**Addendum No. 001**

**Subject: 2020 Classroom Modernizations**  
**SDP Contract Numbers: B-028 C of 19/20 & B-030 C of 19/20**

**Location: Overbrook Educational Center**  
**6722 Lansdowne Ave, Philadelphia PA 19151**

**This Addendum, dated March 6, 2020, shall modify and become part of the Contract Documents for the work of this project. Any items not mentioned herein, or affected by, shall be performed strictly in accordance with the original documents.**

DRAWING NO.  
**14.5**

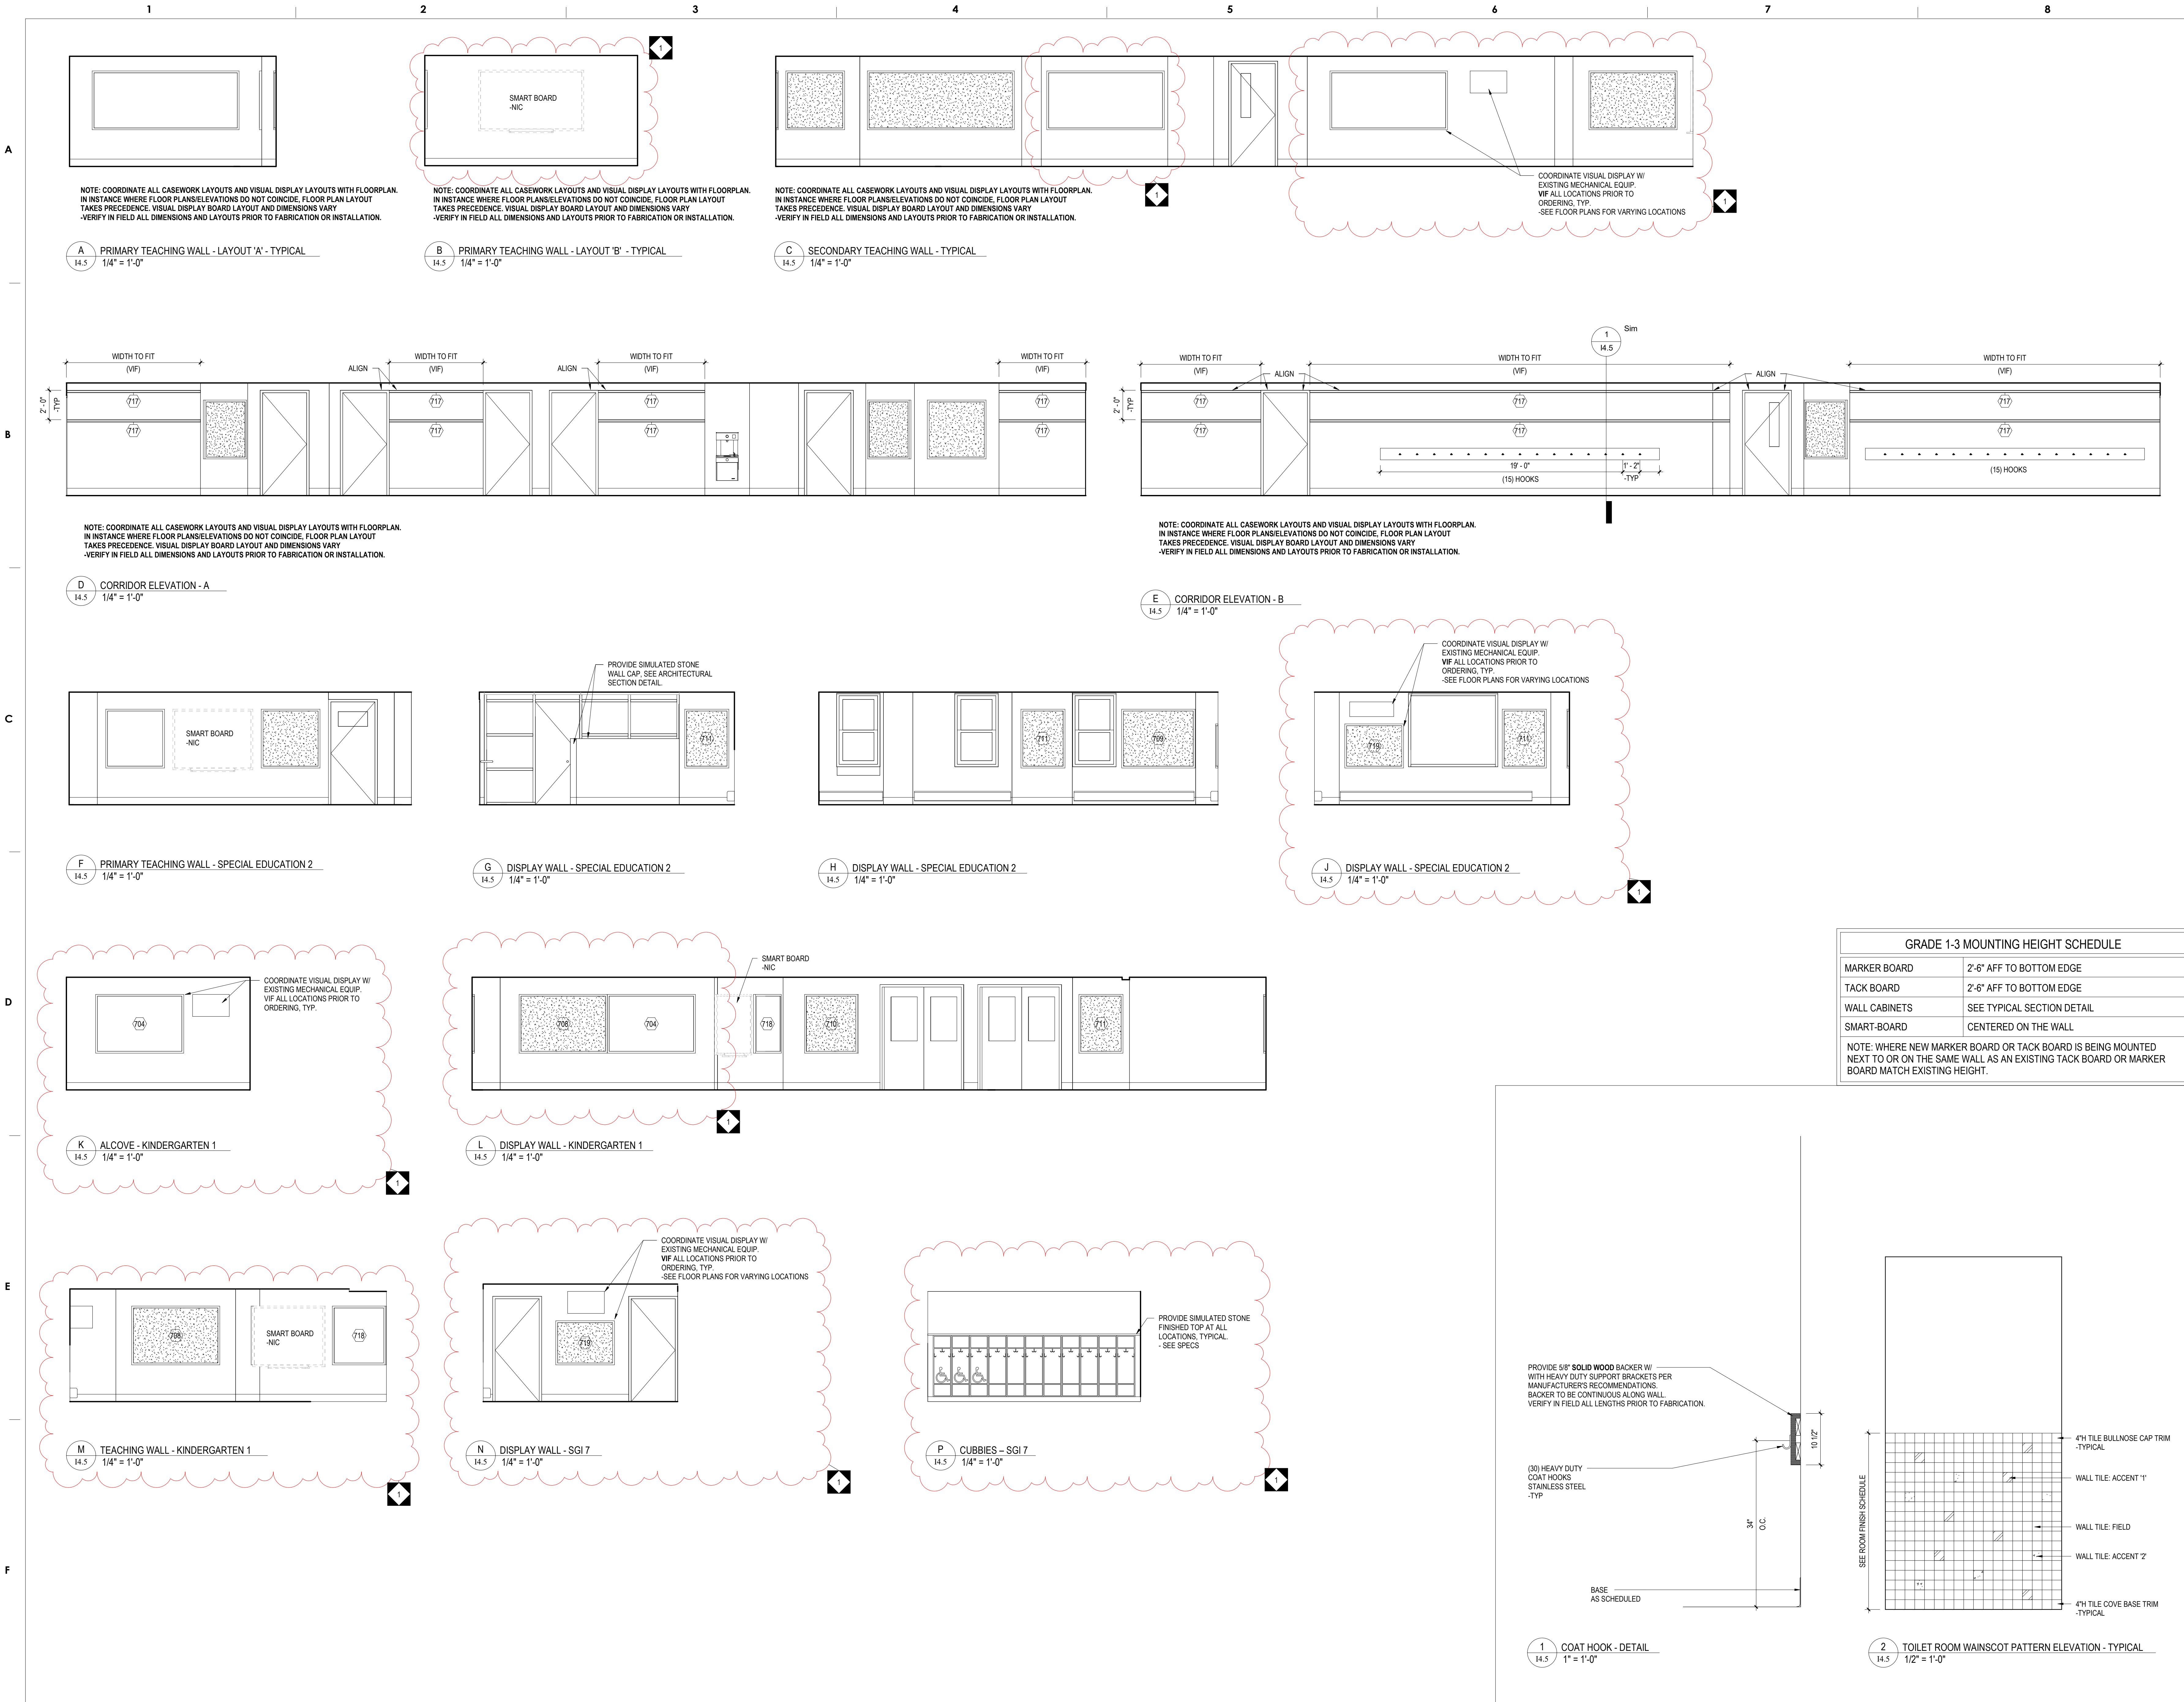
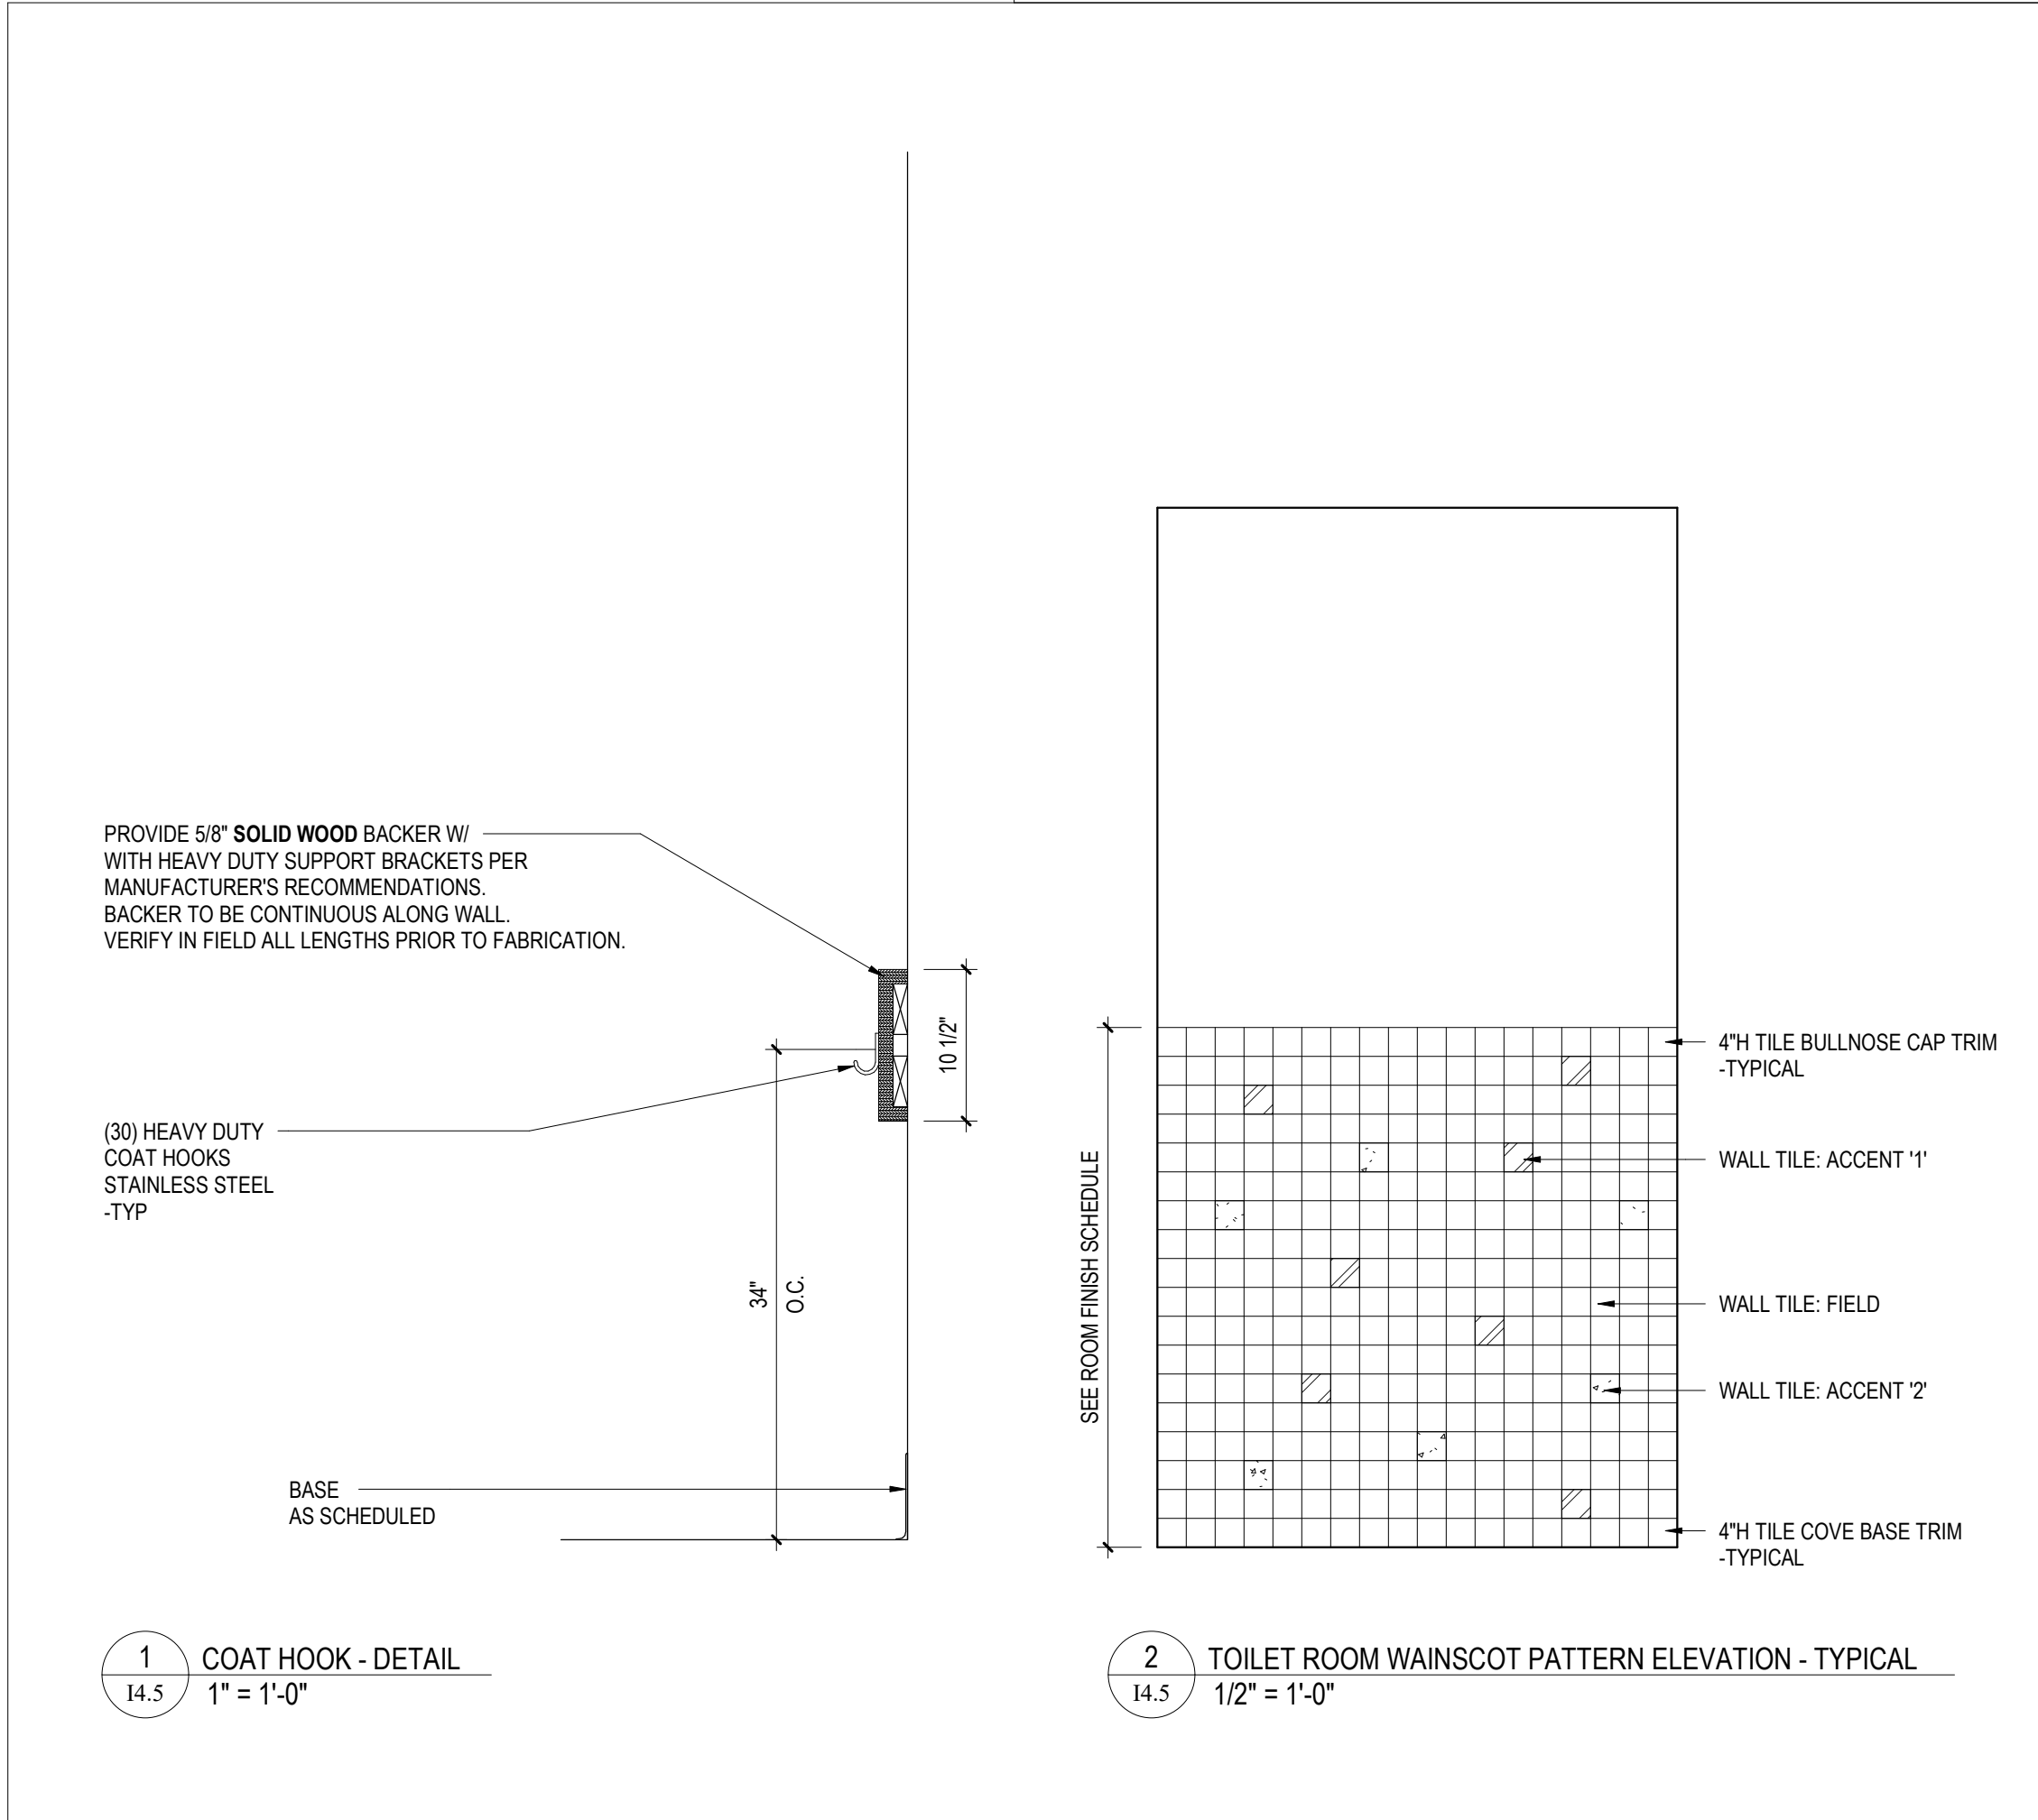
1. REVISE detail B/I4.5 PRIMARY TEACHING WALL LAYOUT 'B' – TYPICAL – Revise to show smart board relocation per the floor plans. Contractor shall reference the note and floor plans for actual sizing of boards, typical.

2. REVISE detail C/I4.5 SECONDARY TEACHING WALL – TYPICAL – Revise to show visual display board size adjustment/relocation of smart board per the floor plans. Contractor shall reference the note and floor plans for actual sizing of boards, typical. Also noted existing mechanical equipment on elevation for contractor coordination for visual display boards.

3. REVISE detail L/I4.5 DISPLAY WALL – KINDERGARTEN 1 – Revise to show visual display board revisions per the floor plans.
4. REVISED detail K/I4.5, to read as: “ALCOVE – Kindergarten 1”.

5. REVISED detail P/I4.5, to read as: “CUBBIES – SGI 7”.
6. REVISE detail M/I4.5 TEACHING WALL – KINDERGARTEN 1 – Revise to show visual display board revisions per the floor plans.

7. REVISED detail J/I4.5, DISPLAY WALL – SPECIAL EDUCATION 2 – Revised Tack Board to 719 and added note to read as: “Coordinate visual display w/ existing mechanical equipment. VIF all locations prior to ordering, typical. – See floor plans for varying locations.

8. REVISED detail N/I4.5, DISPLAY WALL – SGI 7 – Revised Tack Board to 719 and added note to read as: “Coordinate visual display w/ existing mechanical equipment. VIF all locations prior to ordering, typical. – See floor plans for varying locations.
